Catch Housing, Lot 3 Warner NH

September 14, 2026
Revised September 23, 2026

Re: Site Plan Review Comments
Proposed CATCH 34-Unit Multi-Family Development
Tax Map 35, Lot 4-3
9 Route 103 West Warner, New Hampshire

PLAN OF LAND
LOT 3 - ROUTE 103 WEST, WARNER NH,
ASSESSOR'S MAP 35 LOTS 4-3

UTILITY PLAN
CS1701

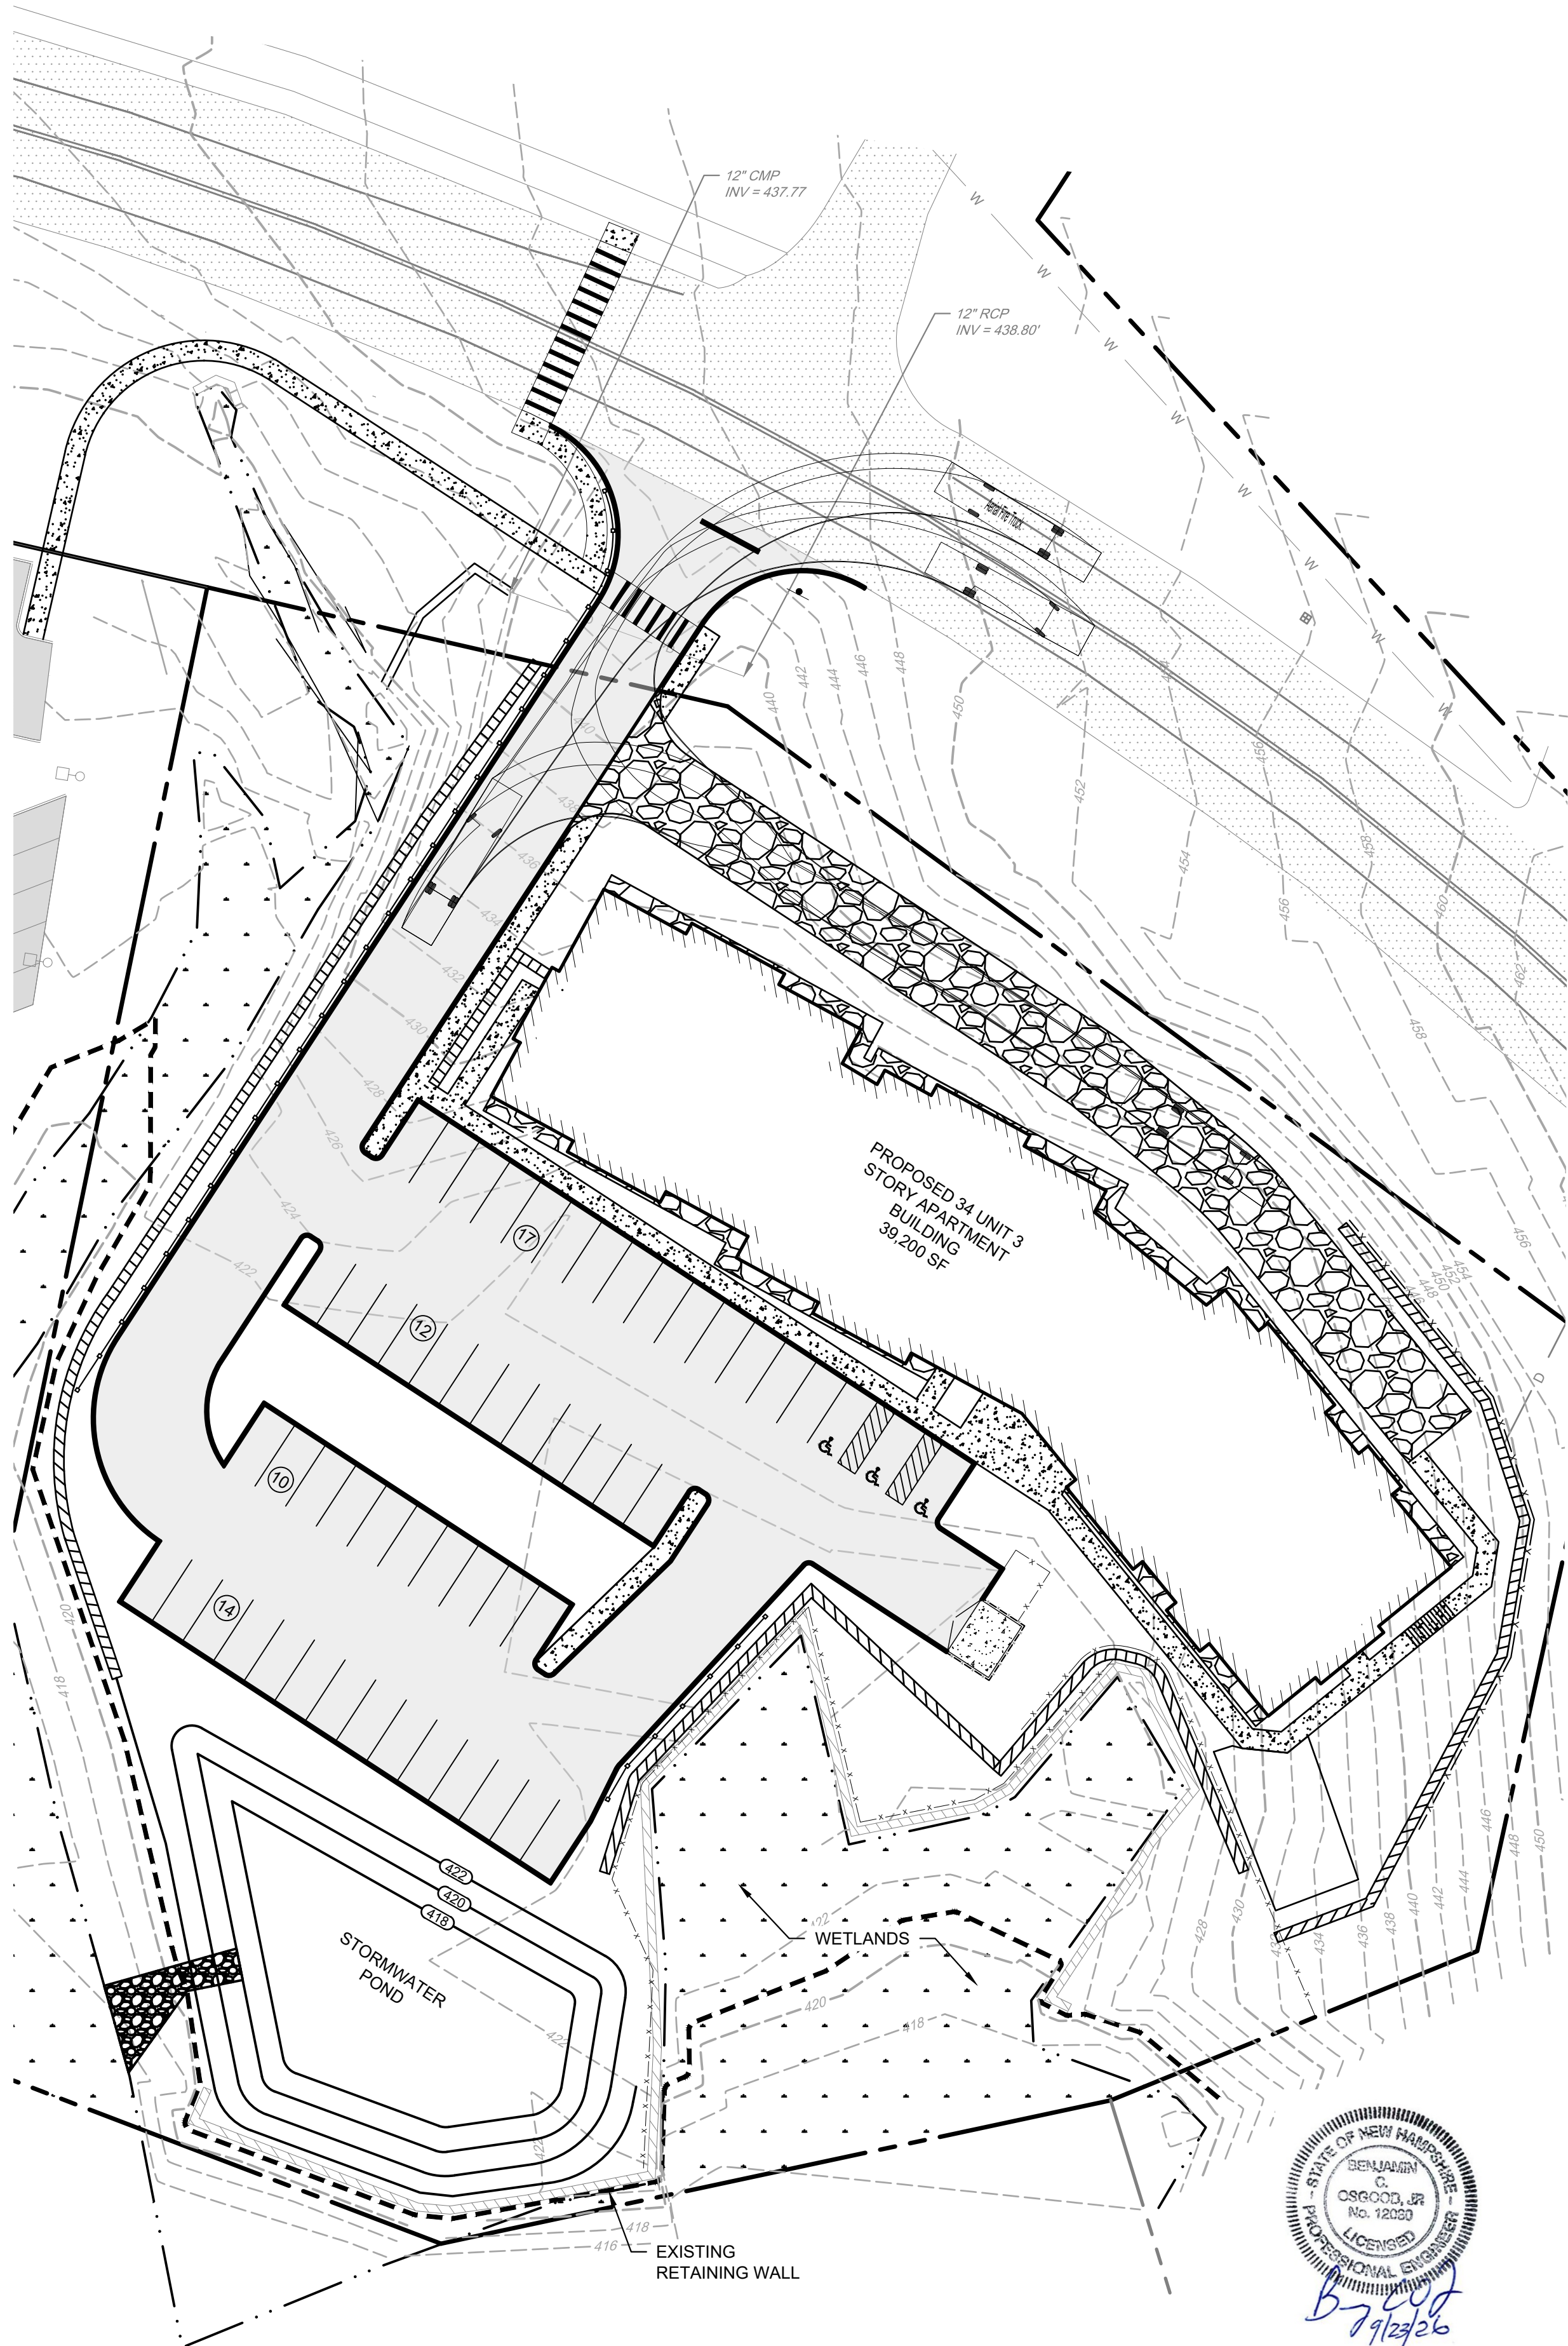
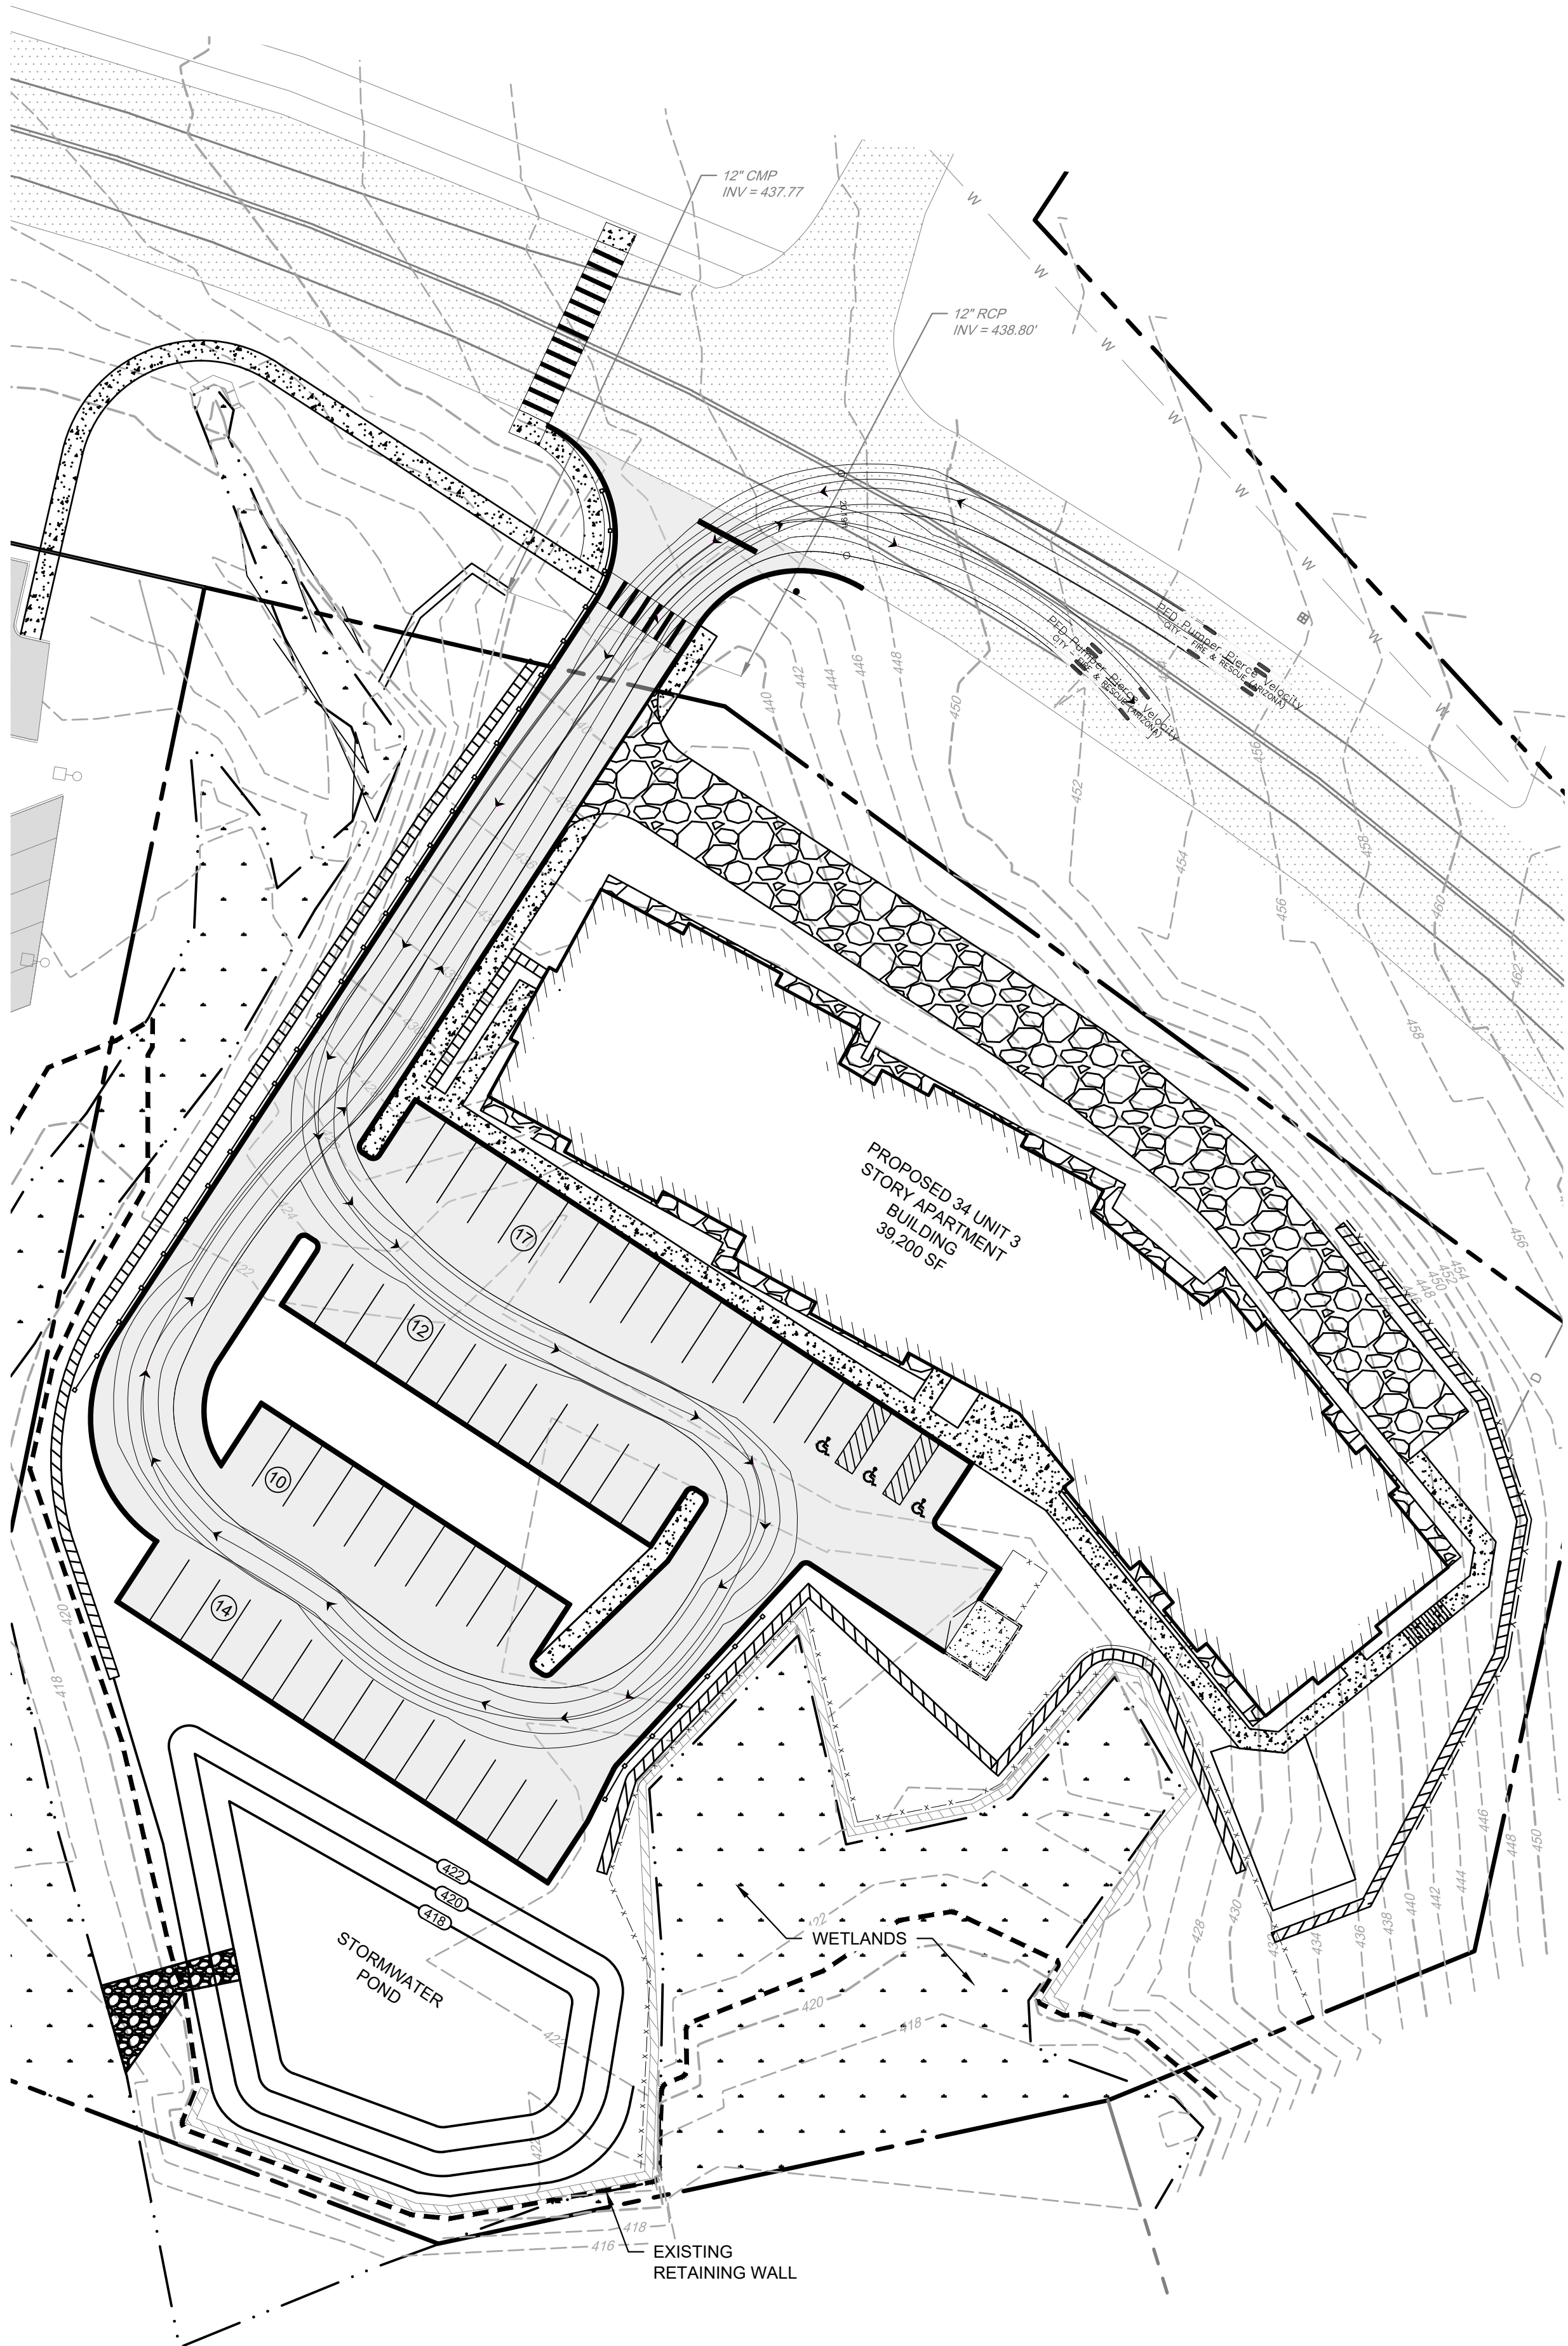
-The Utility Plan (sheet 7) shows the sewer force main and water supply lines will connection to existing stubs at the NW corner of the property at the northern tip of the wetland there. Both of these connections will be crossing a retaining wall and wetland. How will possible impacts be mitigated?

VEHICLE TURNING PLAN - LADDER TRUCK
CS2702

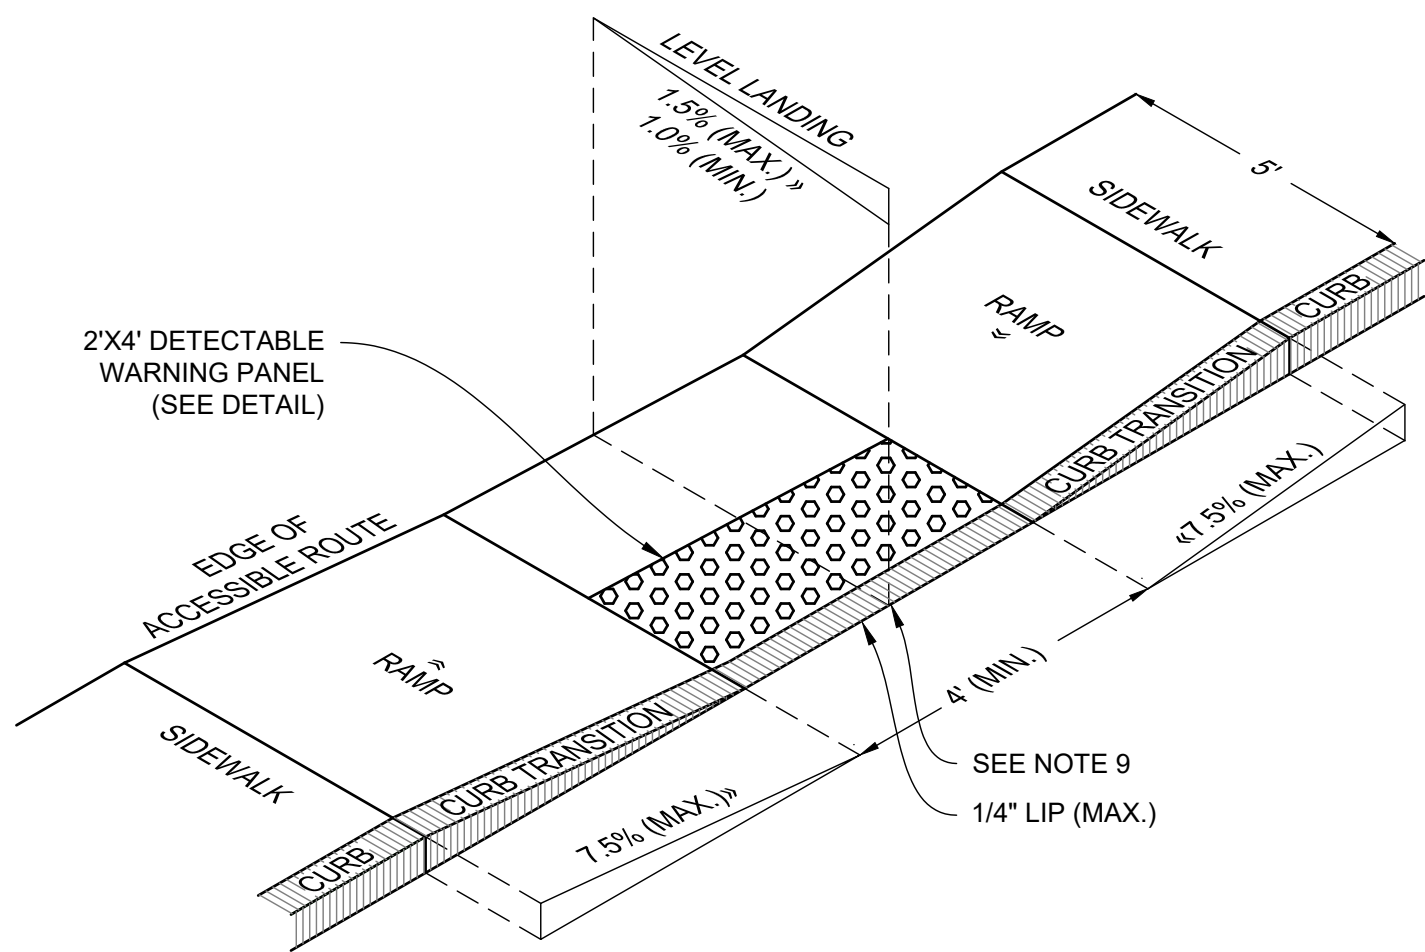
11. The Vehicle Turning Plan - Ladder Truck - CS2701 shows turning moments for paved parking areas but does not show turn radii for 40-foot "Pumper Fire Truck" on to the gravel fire lane located on the northwestern side of the site building.
The turning plan has been revised to show the pumper truck going down the fire lane. An additional turning plan has been added that shows a tower truck as requested by the planning board on September 14, 2026
12. Construction details for the proposed gravel access road should be provided to demonstrate that the proposed gravel road is suitable for access by heavy fire department vehicles.
A detail for the gravel road has been added to the plans
13. Aries strongly encourages the Planning Board to consult with the Warner Fire Chief regarding the utility and design of the proposed fire access road.
The Warner Fire Chief has commented on the plans.
